Star Casino Complex and Switching Station Modification 18

Changes to Multi-Use Entertainment Facility
State Significant Development Modification Assessment
(MP08_0098 MOD 18)

December 2022

Published by the NSW Department of Planning and Environment

Figure 4 | Section of originally lodged (red dashed outline) and amended proposal (Source: RtS)

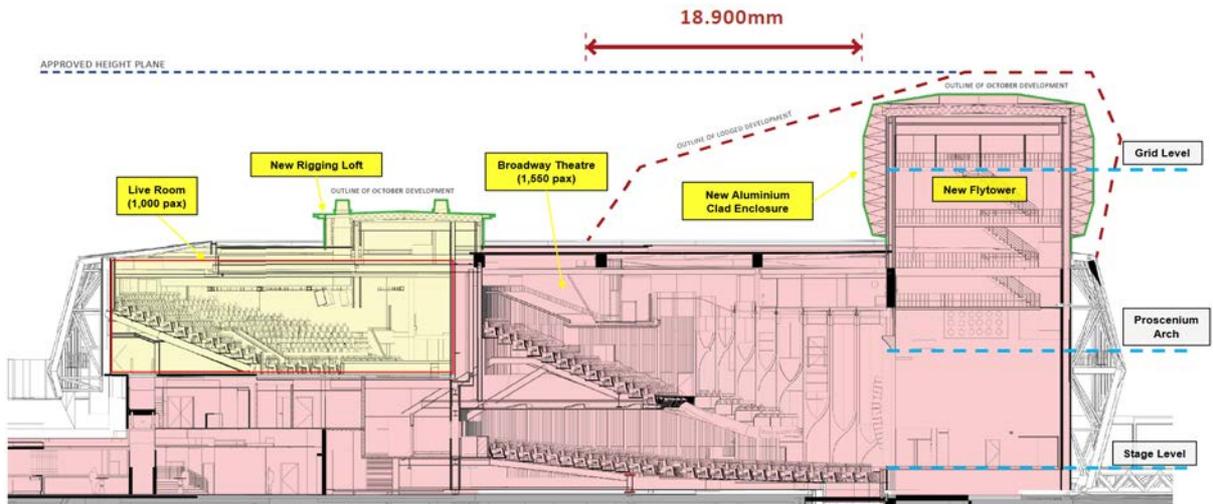
6.2.3 Council initially objected to the height, bulk and scale of the proposal and raised concern with the bulk around the proposed fly tower and new plant and dressing room areas. Council considered the new plant area should be moved to reduce its bulk and associated visual impact.

- amended the form of the fly tower to reduce its height from RL 51.8 m to RL 50.35 m and tighten its external enclosure to reduce its bulk and scale
 - amended the external design of plant room and dressing room space

- reducing the height of the fly tower enclosure from RL 51.8 m to RL 50.35 m
- consolidating the proposed plant room with the dressing room expansion and reducing its height by 1.4m to align with the top of the existing plant room (**Figure 8**)
- amend the proposed façade to cover the fly tower extension only and maintain mid-city views between the fly tower and The Star Grand Hotel (**Figure 4**) and its bulk from residential properties (**Figure 15** to **Figure 21**) and the public domain (**Figure 9**).

Figure 7 | Setback of dressing room and plant expansion (Source: RtS)

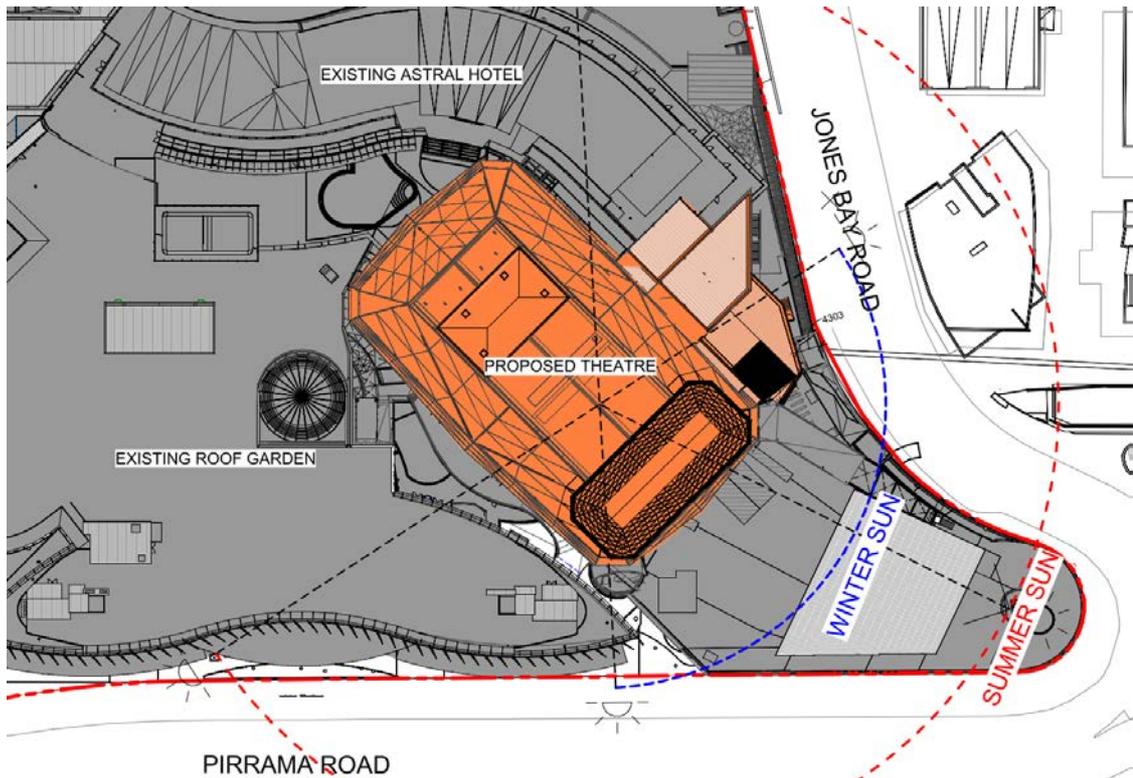
6.2.2 The dressing room and plant addition would be set back from the existing podium that fronts Jones Bay Road by 4.3 m (**Figure 7**). The alterations and additions will add 931 m² of new GFA.

Figure 9 | Comparison of existing (left), lodged (middle) and amended (right) proposal from Pymont Park (top row) and Pirrama Road / Jones Bay Road (bottom row) (Source: RtS)

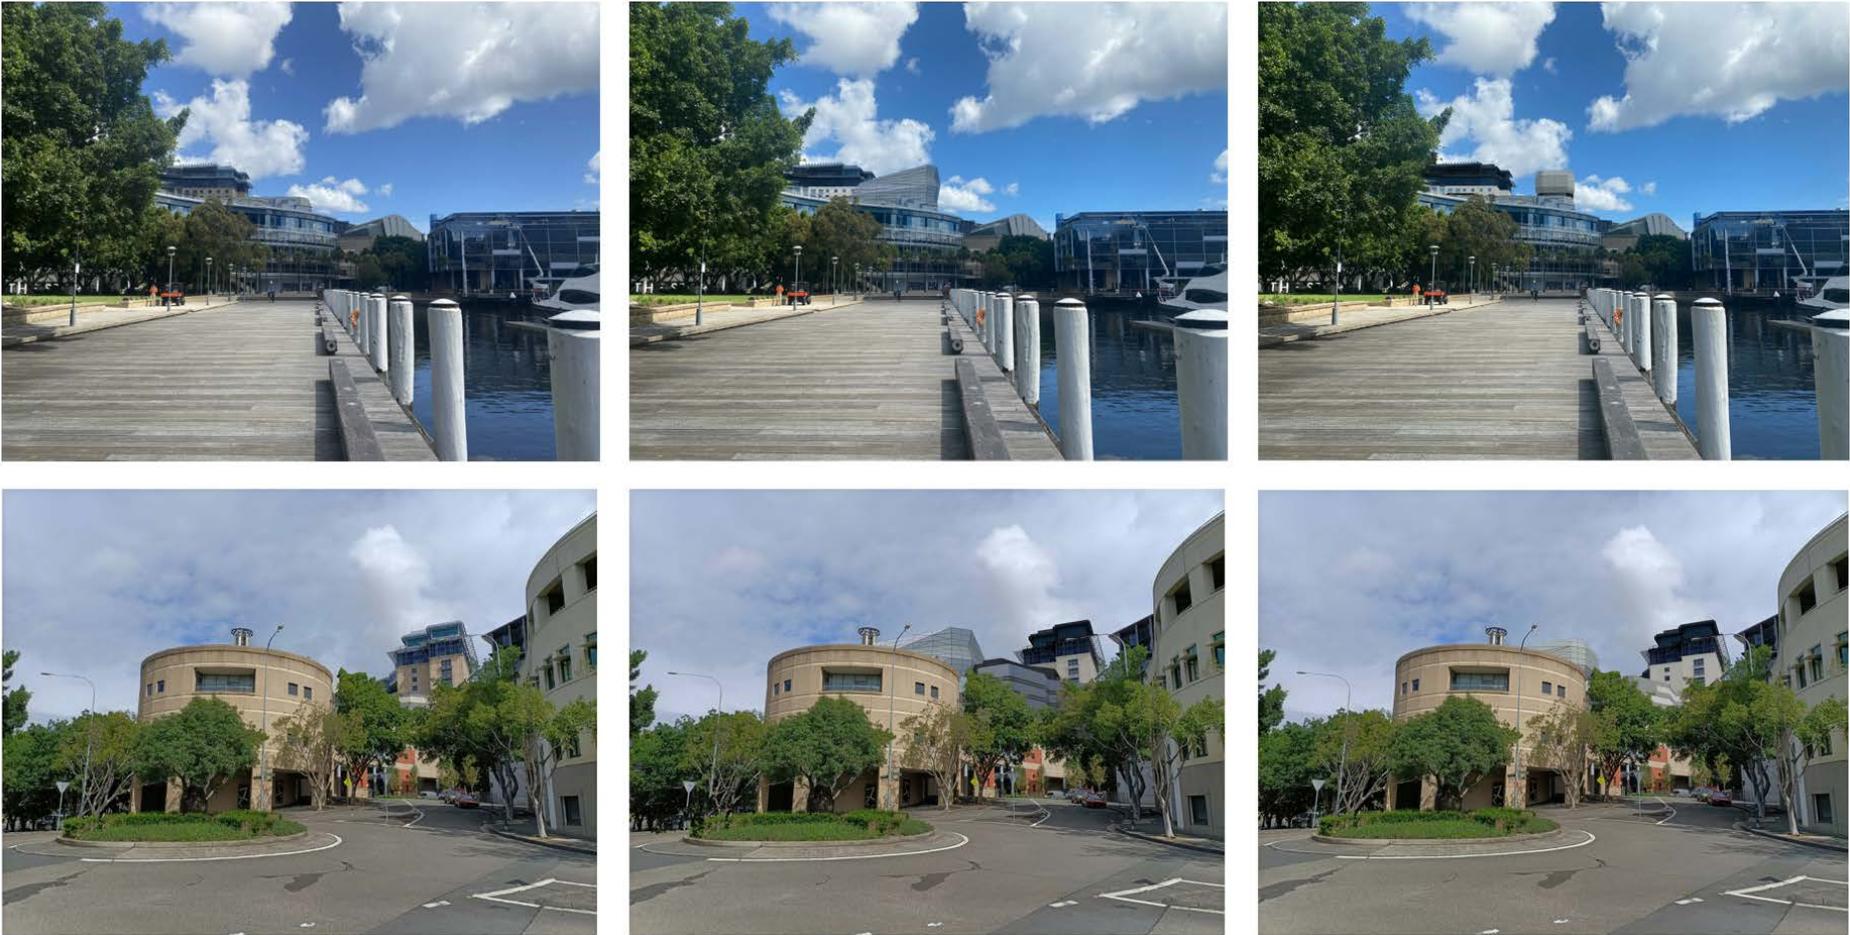
6.4.17 The Applicant's VIA includes montages of the amended proposal from the boardwalk of Pyrmont Bay Park and the intersection of Jones Bay Road and Pirrama Road (**Figure 9**).

Figure 11 | Originally proposed fly tower and dressing room materiality clad in dark grey aluminium (Source: Applicant’s design statement)

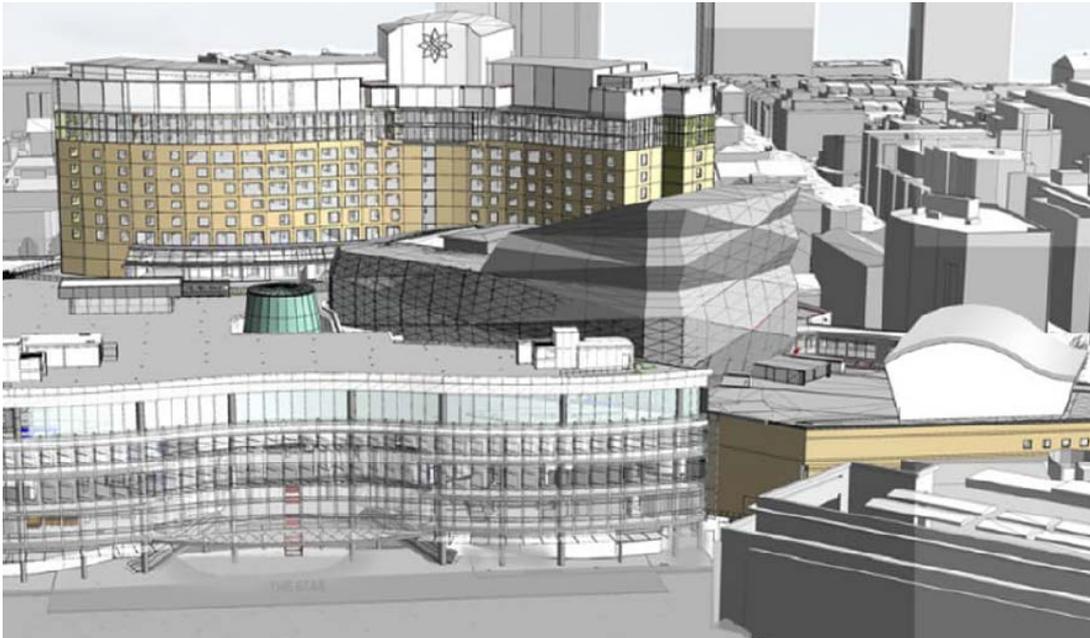
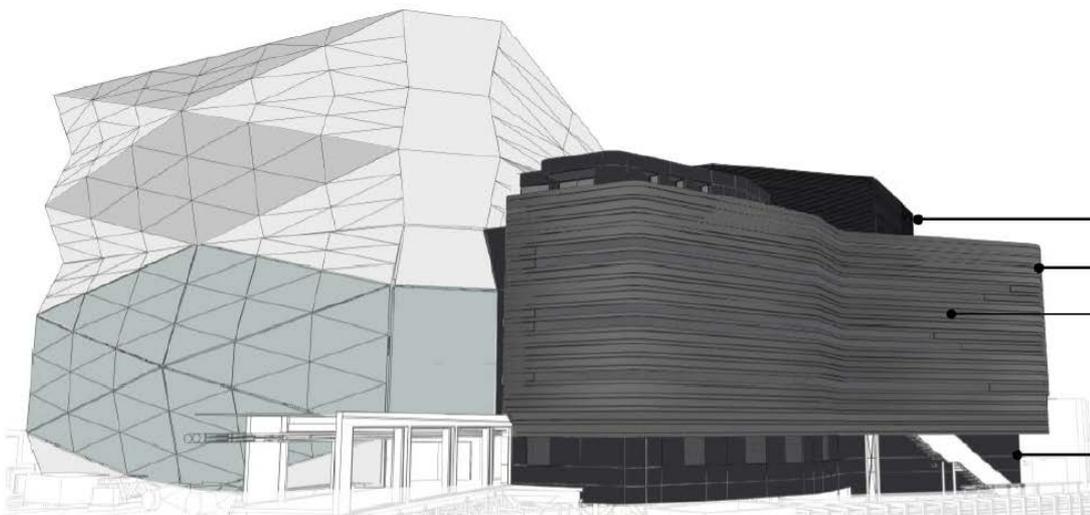
- 6.3.1 The existing MUEF is rectangular in form and clad in triangulated coloured glass profiles, to create a “gemstone” like appearance. The glass varies in tone across the building which creates visual interest as the sun hits the glass surface. The glass façade can be backlit at night.
- 6.3.2 The proposal sought to create a cohesive design, which initially included a significant extension to the existing envelope to accommodate the fly tower and give the impression the building was ‘folding out’ of the existing structure (**Figure 13**). The proposal also included new dark grey aluminum screening to the proposed dressing room extension (**Figure 11**).

- 6.3.4 In response to concerns raised by the Department, Council and in public submissions, the Applicant refined the design to replicate the existing form of the building over the footprint required for the fly tower only which substantially reduces the bulk and visual impact of the proposal (**Figure 12**). The fly tower will be clad in aluminum, which will be less reflective than the existing MUEF, will not be back lit and will include a shadow gap between it and the existing MUEF to ensure the addition is less prominent.

- 6.3.5 Furthermore, the Applicant has amended the plant and dressing room additions into one element and simplified the design to match the levels of sandstone and acoustic louvres of the existing plant room to tie in with the design and materiality of existing structures on the site (**Figure 12**).

Figure 14 | Comparison of western elevation - original (top) and amended proposals (bottom) (Source: RtS)

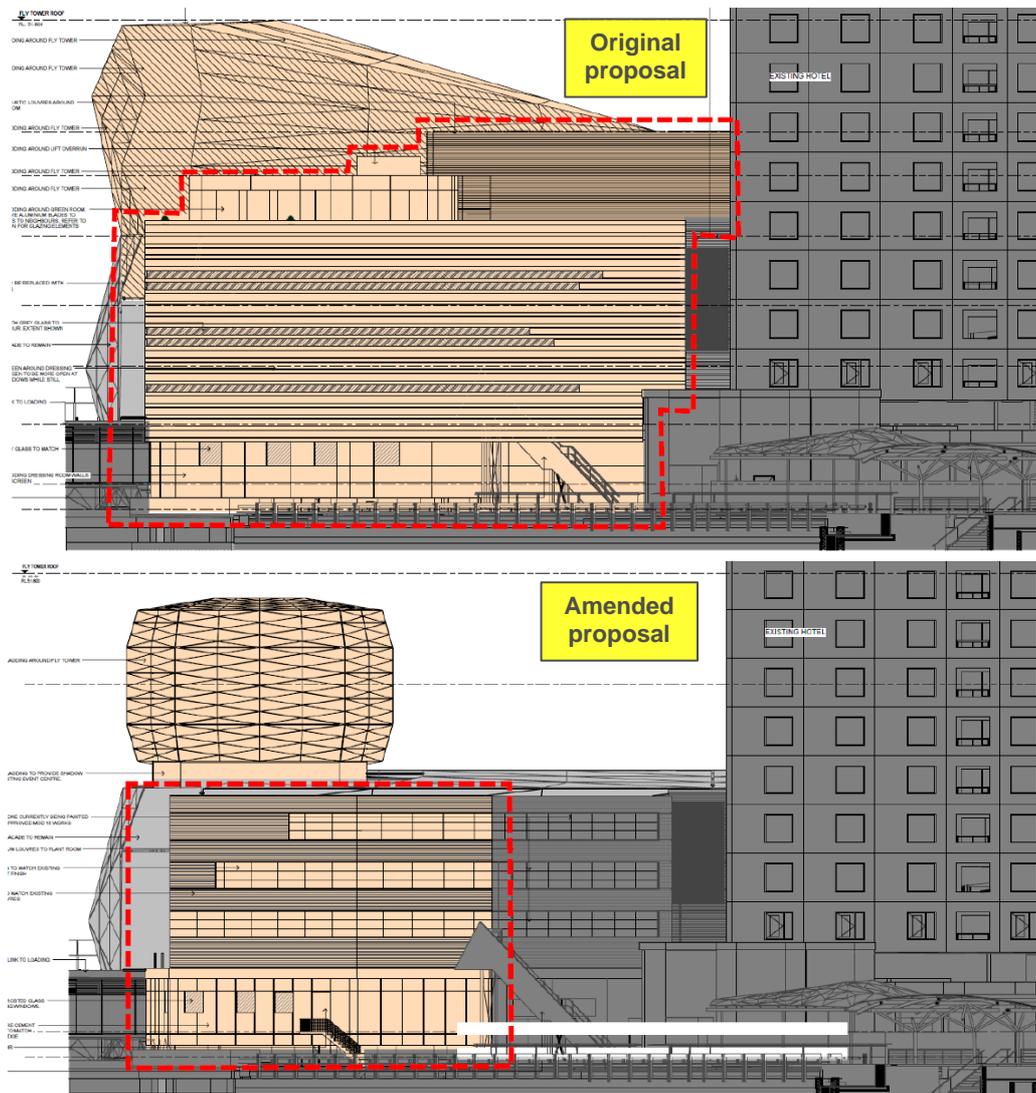
- 6.4.12 The Department is satisfied that the Applicant has carefully considered the design and its amended proposal significantly reduces the view loss impacts (compared to the original proposal) by limiting the additional building height and bulk and wrapping around the proposed fly tower (**Figure 14**).

- simplify the façade around the fly tower to wrap the cladding around its structure and reduce its bulk
- consolidate the plant room and dressing room extension into one structure and align its roof with the existing kitchen and plant room (**Figure 14**)
- remove the horizontal aluminium clad screen wrapping around the dressing room extension and existing plant room to reduce the projection of new built form to Jones Bay Road.

Figure 15 | Severe view loss impacts from L8/9, South of the Watermark Tower (Source: RtS)

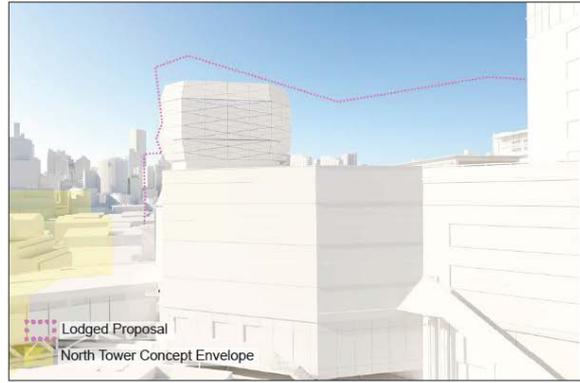
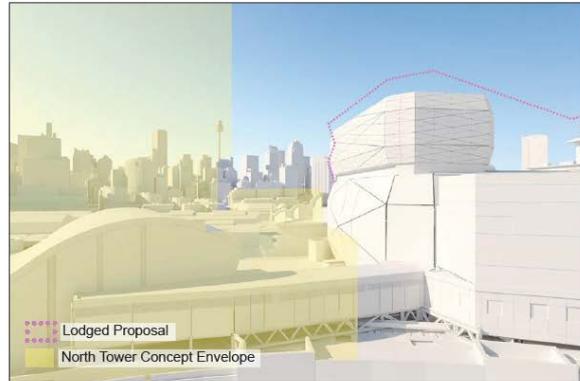
- the Watermark Tower would be:
 - moderate to severe at south facing apartments on levels 8/9, including partial loss of views of the CBD skyline from balconies, living rooms and bedroom/living room windows (**Figure 15** and **Figure 16**)

Figure 17 | Minor view loss impacts from L7, South of the Watermark Tower (Source: RtS)

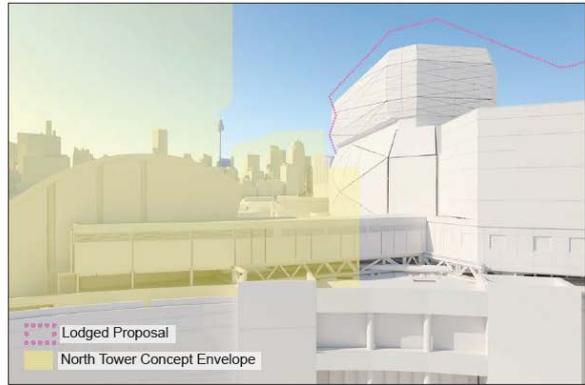
- minor up to Level 7 as existing views toward the CBD are already partially obscured by the existing MUEF and the proposal will only partially further obscure open sky views (**Figure 17** and **Figure 18**).

Figure 19 | Moderate view loss impacts from L8/9, East of the Watermark Pavilion (Source: RtS)

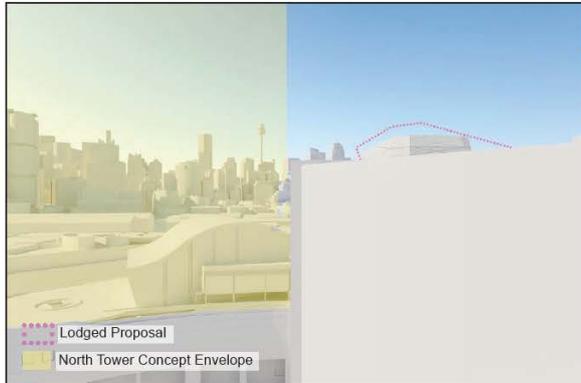
- the Watermark Pavilion would be:
 - moderate at apartments on levels 8 and 9 of the eastern most corner, including partial loss of mid-CBD and open sky views that currently extend above the MUEF (**Figure 19**).
